**ONSITE SEWAGE DISPOSAL SYSTEM**

PROPERTY ADDRESS: 14671 Viburnum Drive

**RE: 14671 Viburnum Dr.  
Septic Plan  
Kalmia Farm, Section 2, Lot 20**

ONSITE SEWAGE DISPOSAL  
SYSTEM DESIGN PLAN  
KALMIA FARM  
SECTION 2  
LOT 20  
REPLACEMENT DWELLING  
(B 17000327)  
TAX MAP 27 GRID 16 PARCEL 22  
TAX ACCOUNT #05-391989  
5TH ELECTION DISTRICT HOWARD COUNTY, MD  
DATE: 2/20/17 SCALE: AS SHOWN  
SHEET 1 OF 2

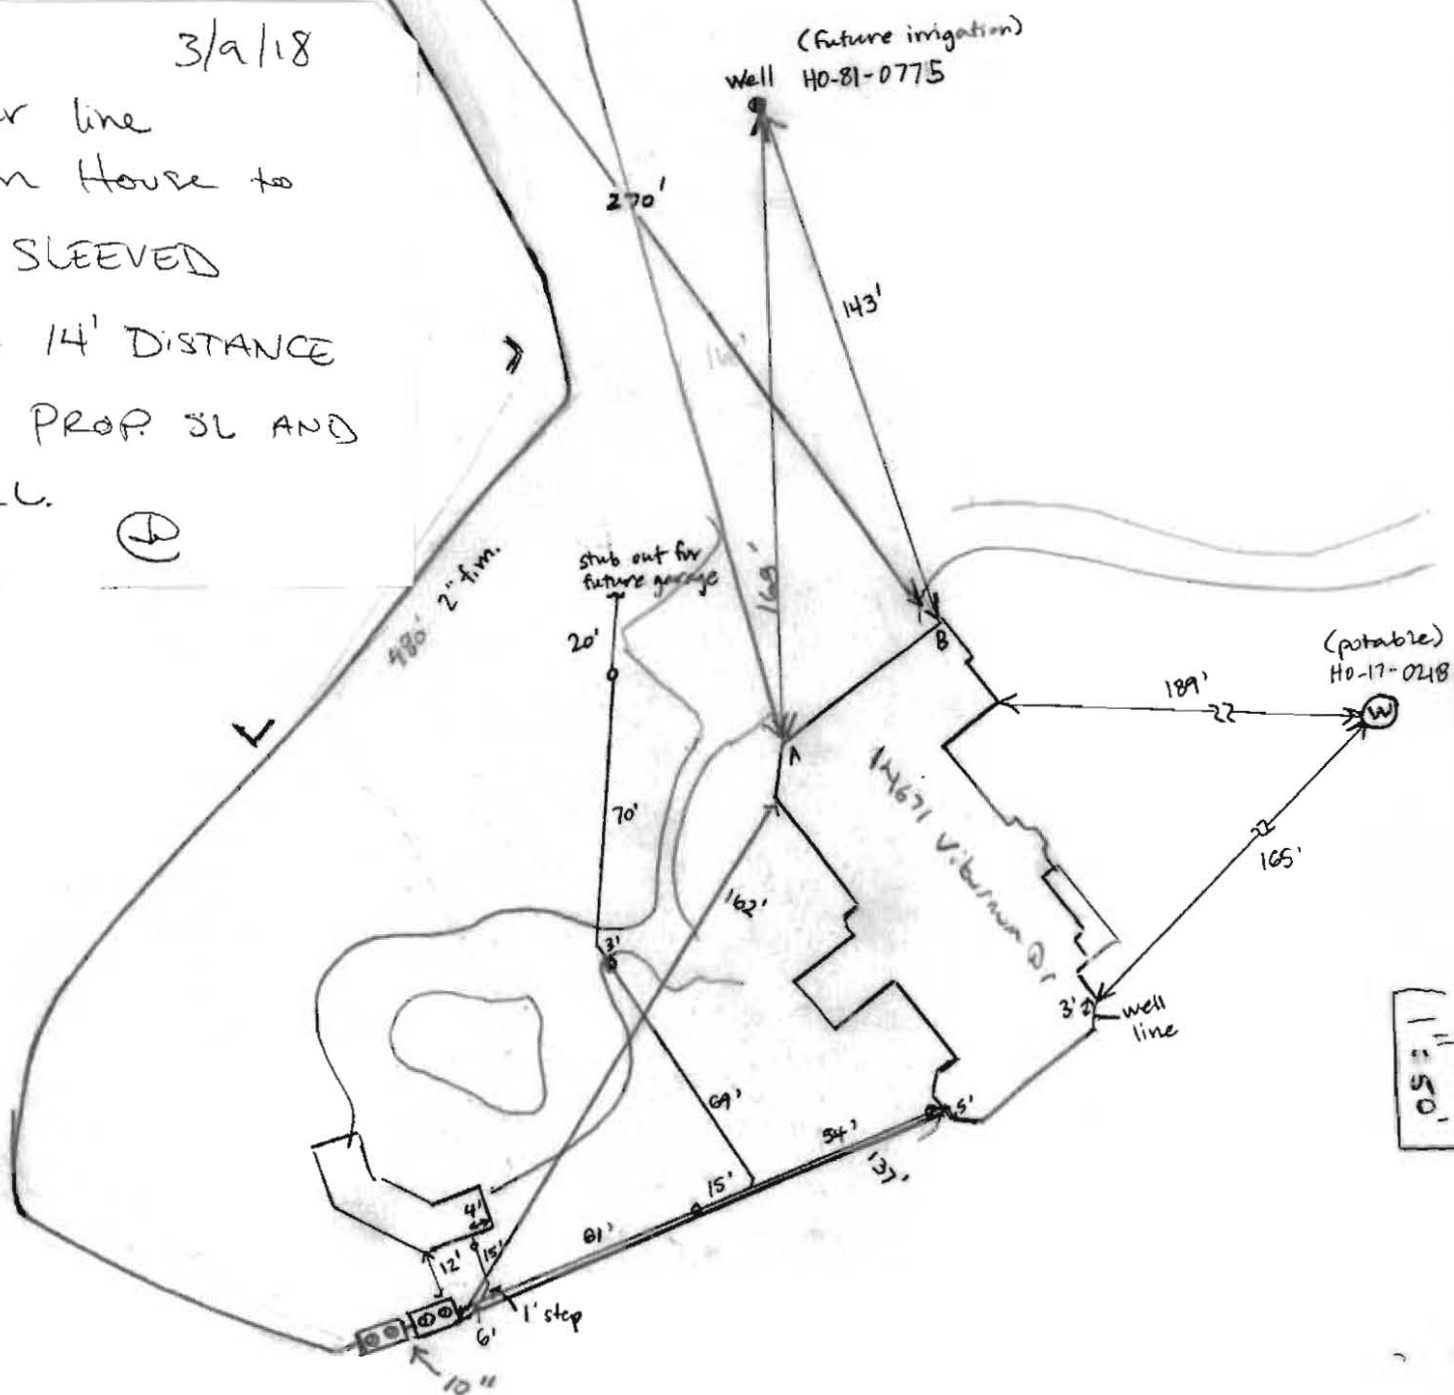
9/25/18 On site for pump + alarm test. Alarm sounds pump pumps effluent to D-box. 1-day storage above the alarm float in the tank. Septic system for the old house must be abandoned. (SC)  
10/25/18 Ex. Septic tank pumped /collyered. Onsite for verification. Ex. well capped. Will be used for irrigation. Letter submitted by homeowners. (Kut)

11/17/17 OK to set tanks as per plan. SDA not staked. Tanks were staked checked w/ laser level off 18". Will need to be adjusted when staked. Call for inspection (Kut)

11/20/17 Set D-box @ start of dip trench. Install 3x6' double on concrete. Concrete does not match plan 12" difference in tanks ends. Pump tank set. One load of #2 stone delivered. OK.

INSTALLATION. 11/29/17-site visit. Contractor on site but not working on septic install. Both tanks were in the ground and partially backfilled, got measurements for As-built, OK to continue. (RR)

12/8/17 2" Force Main installed per plan. No D-box set. Stone onsite. Very clean stone, marble from midland early. Upper trench installed. Area checked. OK to continue (Kut)

12/11/17 T2 + T3 complete. T2 covered + T3 left open for inspection. 3' wide. 2.5' to stone. (SC) 12/12/17 D-box installed, connected to fin. + trenches. Need house sewer line and pump + alarm. (SC) 3/14/18 Sewer house connections complete. Need pump + alarm. (SC)

Top trench not talled out of Area  
 due to contours, and large trees.  
 > 100' from ex. well.

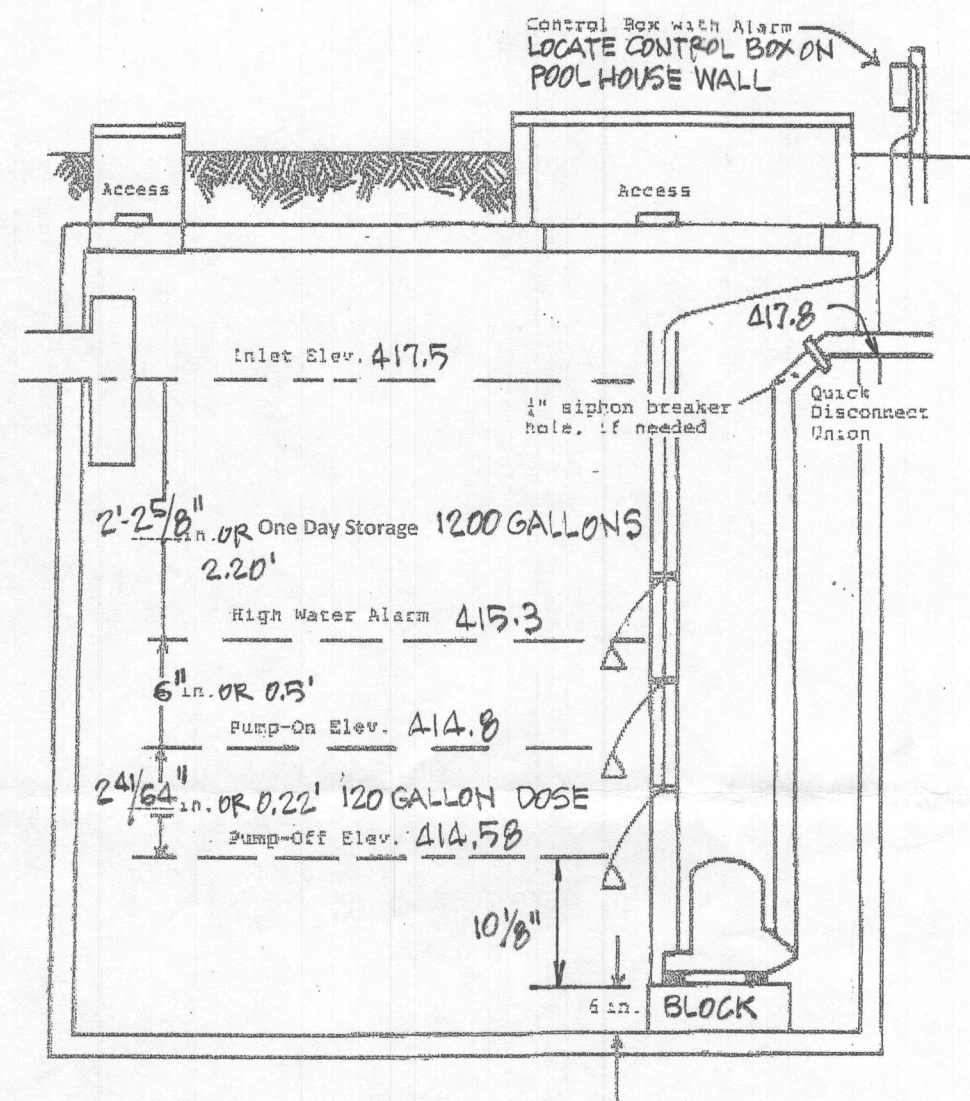
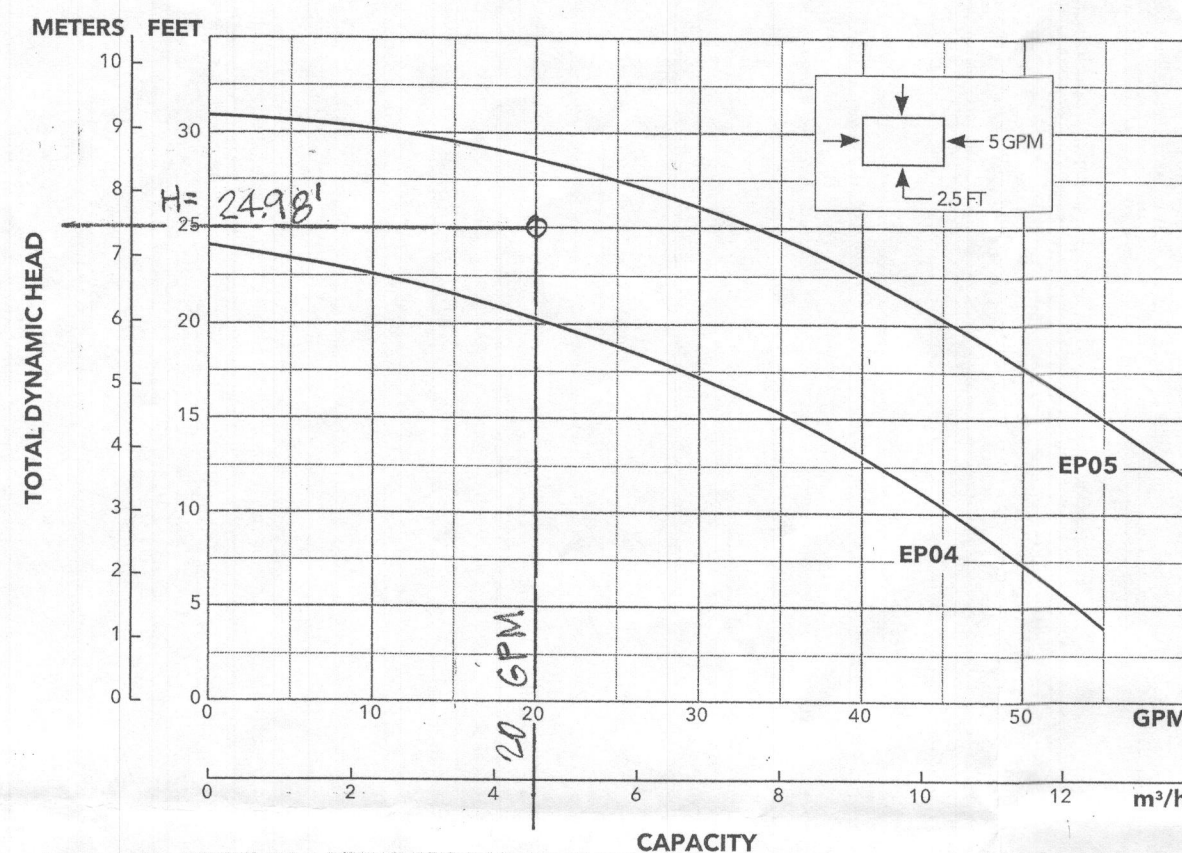
- 1.) The EP05 pump should be sufficient but how do you arrive at 20 gpm on the pump curve? If the total dynamic head is 25 then the pump will yield approximately 33 gpm according to the curve.
- 2.) Is the garage septic line a force main or 4 inch pvc?

There needs to be a clean-out shown every 70 feet on the line. Also, the septic line located underneath the driveway needs to be sleeved.

I could redline the plan to show to indicate a 4 inch line, cleanouts and a sleeve so this plan can be used for the future garage and pool house.

- 1.) Change trench design calculations to match septic specs (see attachment).
- 2.) Place initial and first replacement system at top of SDA (see attachment).
- 3.) If TDH = 25.74, then GPM = 33. This # is based on graph provided on plan. (see attachment).
- 4.) Pump will be EP05
- 5.) Runtime =  $150/33 = 4.54$  minutes

1. Trench calculations and design have been revised to accommodate 8 bedrooms.
2. Trench layout has been adjusted to accommodate the initial, first and second replacement systems.
3. The design head has increased due to the repositioning of the distribution box. Since the design flow has increased, the force main has increased in size to 2". This will place the pump discharge within the median output range. The discharge rate is a function of a quantity dose over a prescribed time.
4. Pump will remain EP05.
5. Pump run time has been revised to 8 minutes.
